# Technical Service Bulletin

## 40 Clicking noise from wheel bearing

40 17 74 2024318/8 July 19, 2017. Supersedes Technical Service Bulletin Group 40 number 17-68 dated July 11, 2017 for reasons listed below.

Figure 1. Area to apply paste.

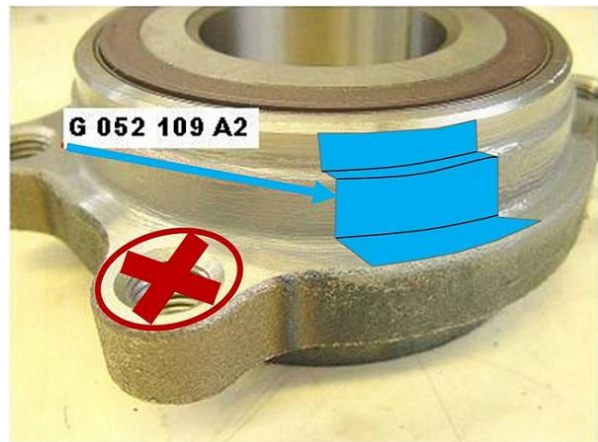
1. On the affected side(s), remove any corrosion and dirt from the wheel bearing housing and the wheel bearing.
2. Using a brush, apply a thin coat of paste part number G 052109A2, using about .21 ounces or 6 grams (roughly 1/20) from the tube on the wheel bearing housing as shown (Figure 1). Make sure not to apply any paste on the threads.
